UNITED STATES
NUCLEAR REGULATORY COMMISSION
REGION II
SAM NUNN ATLANTA FEDERAL CENTER
61 FORSYTH STREET, SW, SUITE 23T85
ATLANTA, GEORGIA 30303-8931

EA-07-173

SUBJECT: FINAL SIGNIFICANCE DETERMINATION FOR A YELLOW FINDING AND
NOTICE OF VIOLATION (NRC INSPECTION REPORT NOS.
05000348/2007011 AND 05000364/2007011, JOSEPH M. FARLEY NUCLEAR
PLANT)

Unit 2 RHR MOV 8811A Preliminary Yellow Finding

Cause Evaluation (continued)

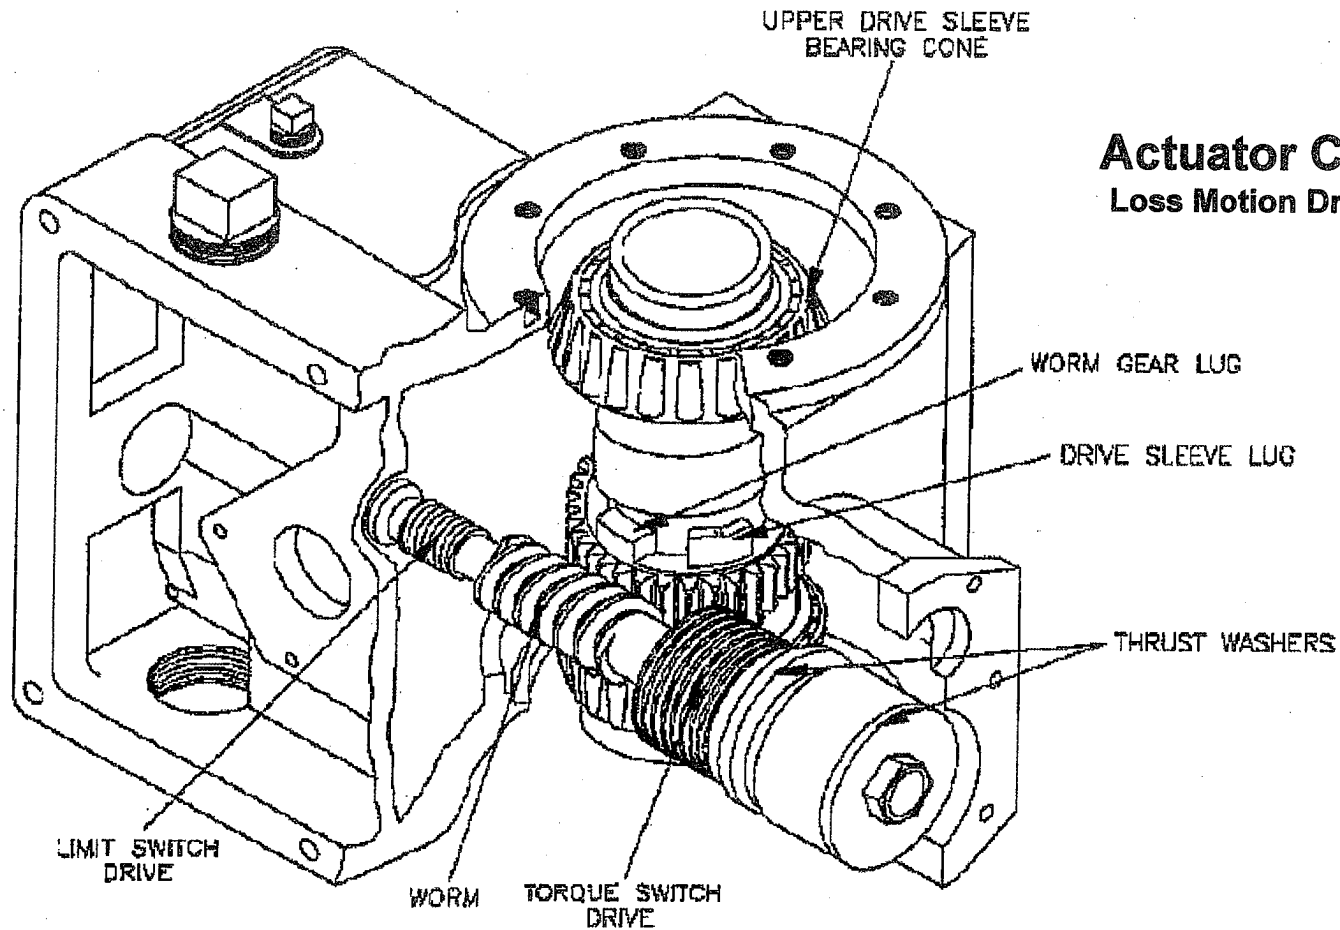
- ◆ Identified failure mechanisms:
 - Hammerblow effect of opening valve
 - OEM-identified contact guide pitting

- ◆ **Bottom line:** Identified failure mechanisms, acting in concert, caused Unit 2 MOV 8811A valve function issue, and are not associated with other encapsulated valves.

Torque Switch Displacement – Hammerblow

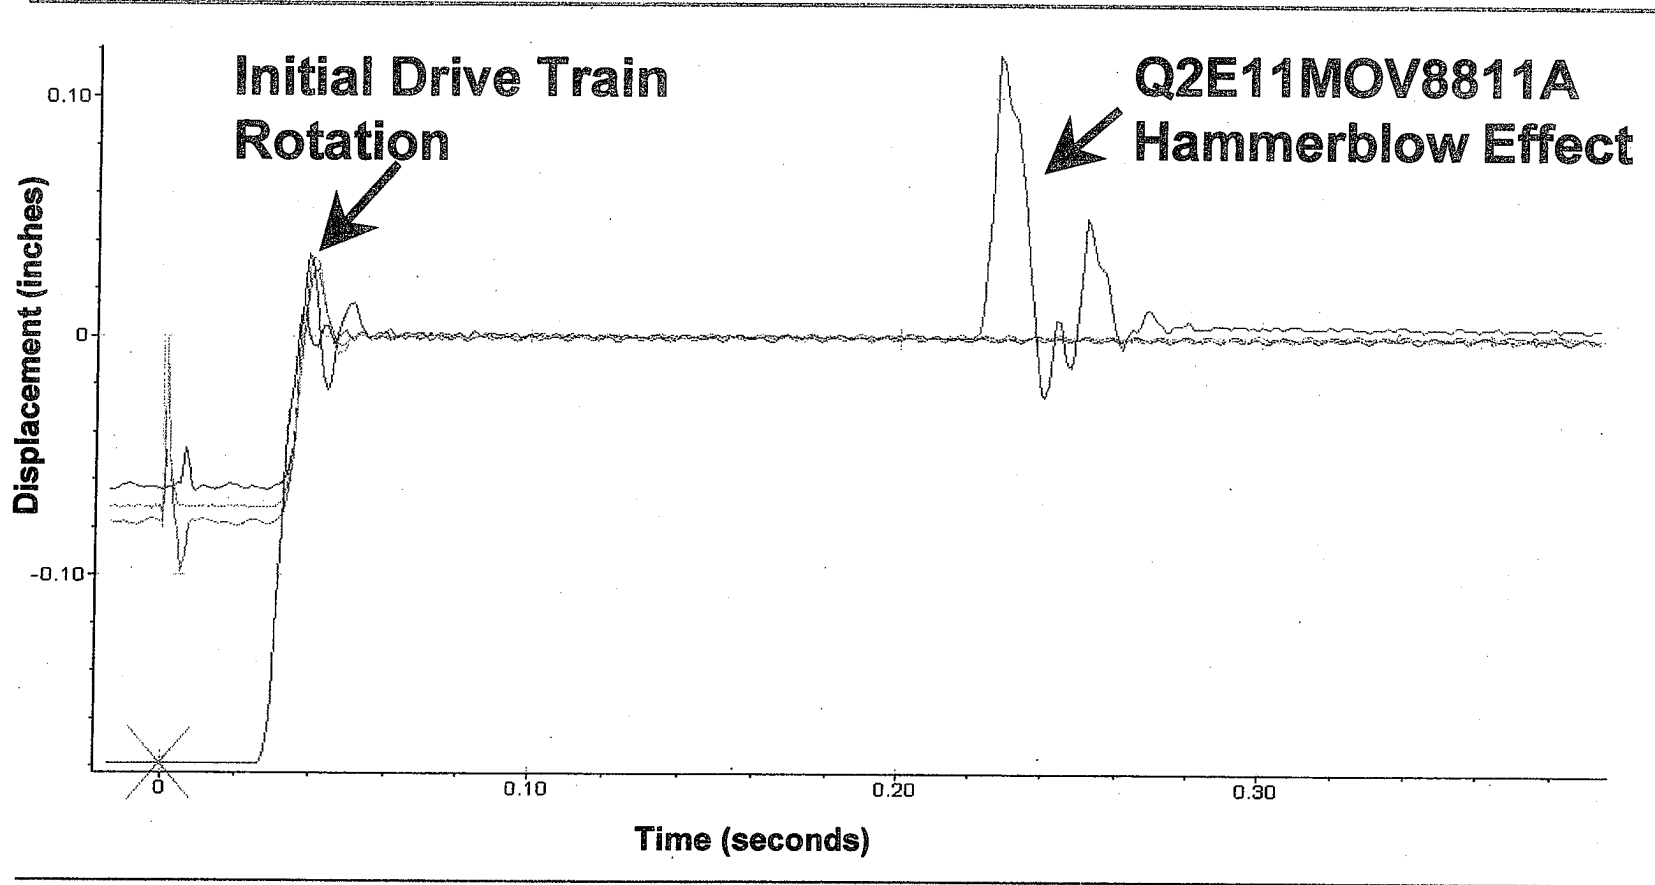
MOV 8811A as compared to MOVs 8811B, 8812A and 8812B open spring pack displacement.

- ◆ Root cause is Hammerblow forces placed on the torque switch, in concert with pitted area on the contact guide.
- ◆ Unit 2 MOV 8811A has a unique actuator configuration and operational response, as compared to Unit 2 MOV 8811B and all other encapsulated valves on both units.
- ◆ No motor degradation other than ordinary wear identified.
- ◆ Therefore, the other RHR Train suction Valve (MOV 8811B) would not be affected by a Common Cause.
